UNITED STATES PATENT AND TRADEMARK OFFICE

APPLICATION NO.	FILING DATE	FIRST NAMED INVENTOR	ATTORNEY DOCKET NO.	CONFIRMATION NO.
10/811,194	03/26/2004	Paul A. Fleenor	HE0104A	2934

Office Action Summary	Application No. 10/811,194	Applicant(s) FLEENOR ET AL.	
	Examiner Thanh-Tam T. Le	Art Unit 2839

DETAILED ACTION

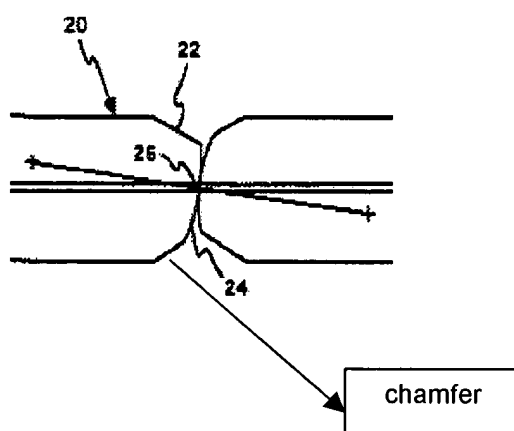
Regarding claims 29-30, 37-38 and 44, Lurie et al., figure 2, disclose a ferrule (20) comprising : a ferrule body extending lengthwise between opposed front and rear faces to define a longitudinal axis (28). The ferrule body defining a lengthwise extending bore capable of receiving an end portion of an optical fiber and a chamfer (see a figure below), the chamfer being adjacent to the front face. Wherein the front

face of the ferrule body including a compound surface having a ground portion (24) and an unground portion (22), the bore opens through a hemispherical ground portion.

Regarding claims 36, 43 and 50 the ferrule body including a chamfer (see a figure above) and the unground portion is disposed proximate to the chamfer.
